Release note

Product: PTZ310/PTZ330/PTZ310N/PTZ330N

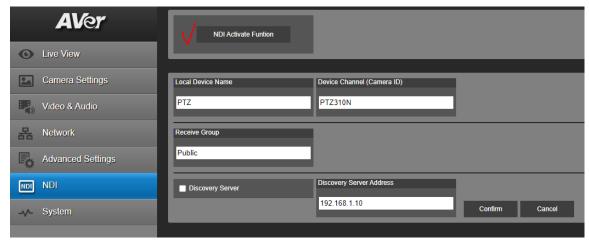
FW version	V0.0.0000.83
Release date	2022/12/23
New feature	1. Able to set SSHD on/off in webpage. (Network > SSHD)

1. Able to set SSHD on/off in webpage. (Network > SSHD)

2. Able set HTTPS only/on/off in webpage. (Network > HTTPS)

3. Added VISCA command

Able to support CISCO codec plus. (Project base installation requirement.)	
Improvement	Improvement: Able to adjust White Balance settings on Microsoft Teams.	
	Bug: Correct to show the NDI status when deactivating NDI from webpage.	
	Improvement: Enhance the NDI activation process, please use V83 for the NDI ac	tivation
	function, when the user enters the License key code to activate, AVer server will re-	eject the
	activation of the old FW (V78).	
Known issue	If the video mode (web page) setting in IP streaming only/ NDI only, when USB p	ort
	connect with PC, still see the device name of PC side, but no UVC output.	
	The NDI.5 Reliable UDP feature is not supported.

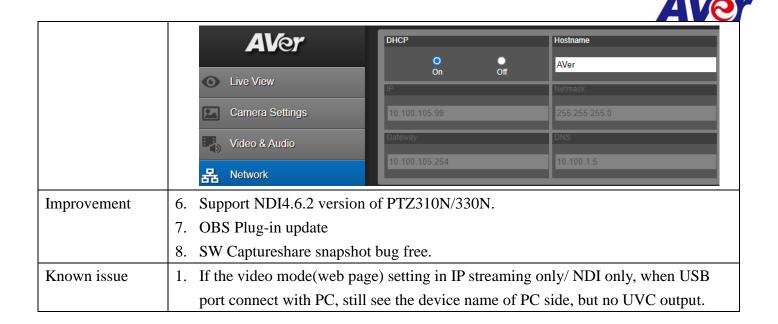
FW version	V0.0.0000.78	
Release date	2022/02/08	
New feature	5 Able to set UAC on/off in webpage (Video & Audio > UAC)

6. Added the ability to do NDI activate function and settings.

7. Added VISCA inquire command

AVer
	8. Able to support LLDP (Link Layer Discovery Protocol).
Improvement	4. Improve RTMP audio on Vimeo
	5. Improve White Balance/ One Push function to save the R gain / B gain value.
Known issue	3. If the video mode (web page) setting in IP streaming only/ NDI only, when USB port
	connect with PC, still see the device name of PC side, but no UVC output.
	4. The NDI.5 Reliable UDP feature is not supported.
